ATTACHMENT 2

TO P-92159

PROPOSED CHANGES

NO SIGNIFICANT HAZARDS
CONSIDERATION ANALYSIS

FSV TRANSITION ORGANIZATION

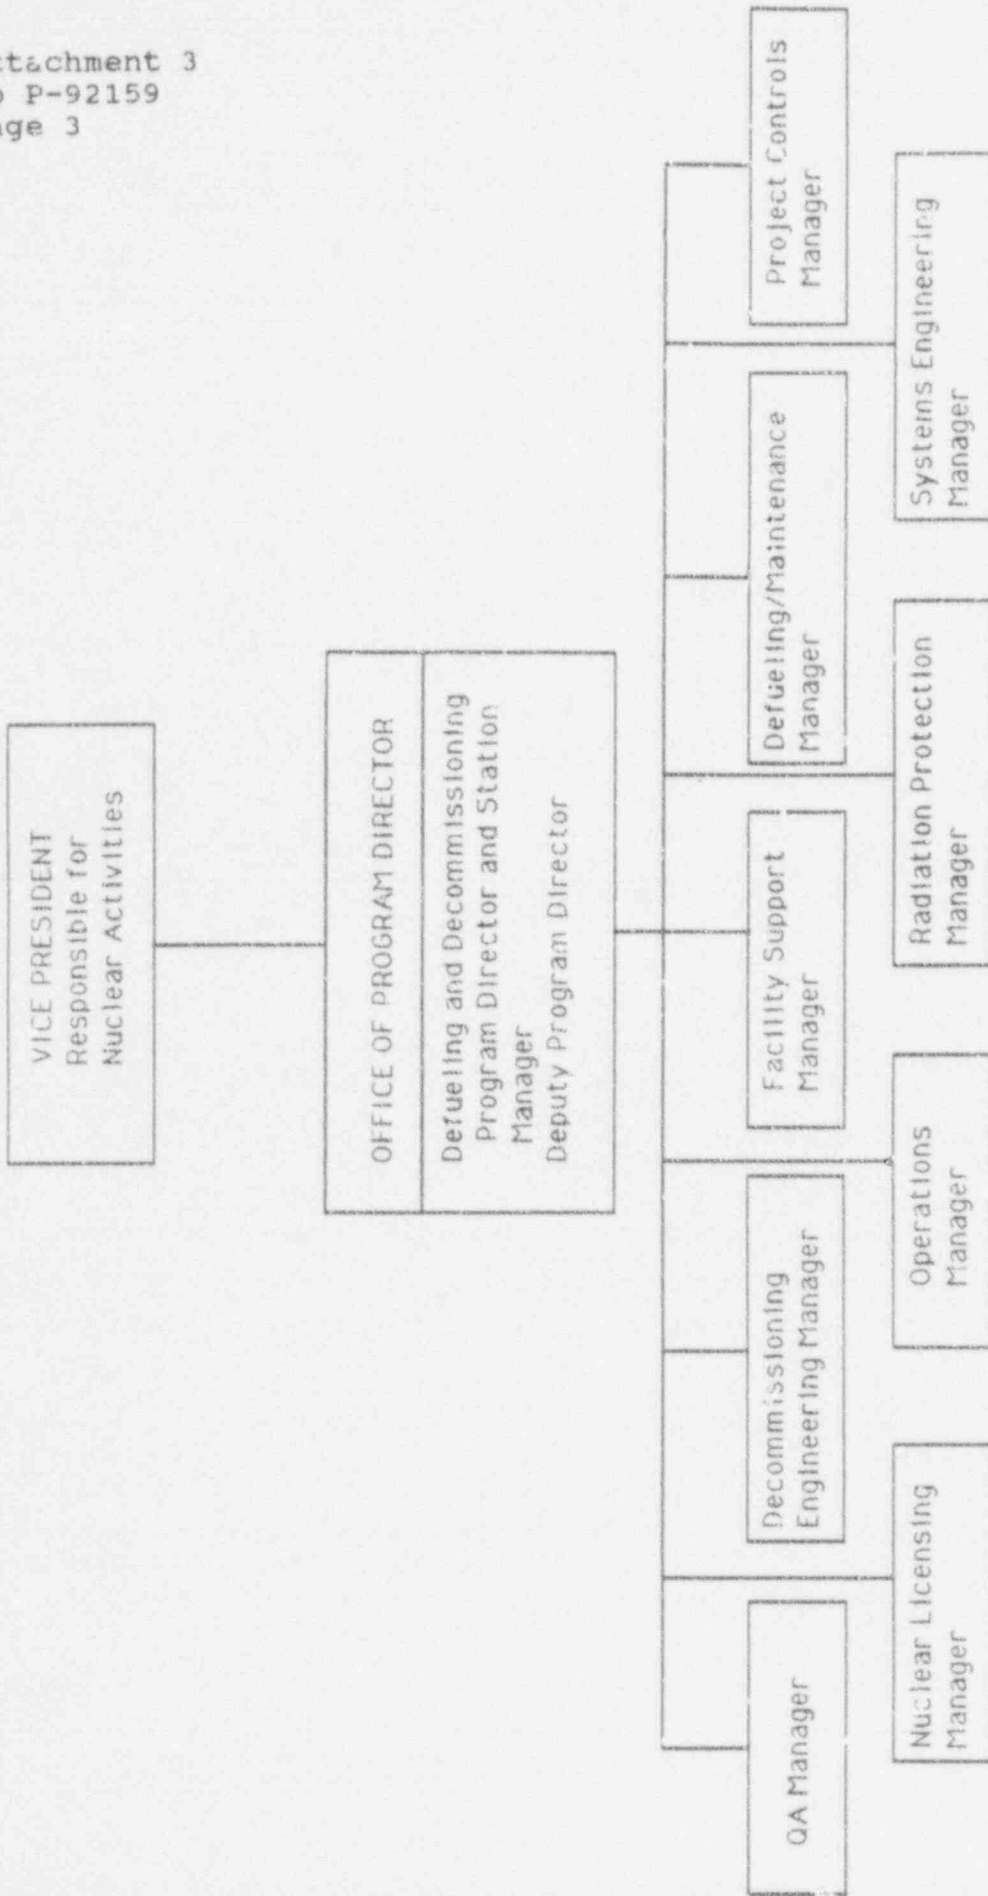
Plant Operations Review Committee (PORC) membership has been revised to include the following:

Defueling and Decommissioning Program Director and
Station Manager (formerly Manager, Nuclear
Production and Station Manager)
Deputy Program Director (new position)
Facility Support Manager (formerly Nuclear Training and
Support Manager)
Radiation Protection Manager (formerly Superintendent of
Chemistry and Radiation Protection)
Operations Manager
Defueling/Maintenance Manager (new position)
Systems Engineering Manager
Decommissioning Engineering Manager (new position)

Nuclear Facility Safety Committee (NFSC) membership has been revised to include the following:

Chairman
Defueling and Decommissioning Program Director and
Station Manager (formerly Manager, Nuclear Production
and Station Manager)
Deputy Program Director (new position)
Nuclear Licensing Manager (formerly Manager, Nuclear
Licensing and Resource Management)
Systems Engineering Manager (formerly Manager, Nuclear
Engineering Division)
Decommissioning Engineering Manager (new position)
Quality Assurance Manager (formerly Manager, Quality
Assurance Division)
Radiation Protection Manager (formerly Nuclear Training
and Support Manager)
Safety and Security Director
Consultants, as required

Justification: The re-organization described above is illustrated on the attached organization chart, provided for information. This organization will improve internal communications by reducing overall management positions and eliminating at least one level of management. Also, this organization focuses on the Office of the Program Director which will facilitate the transition into the Early Dismantlement decommissioning organization upon the completion of defueling.
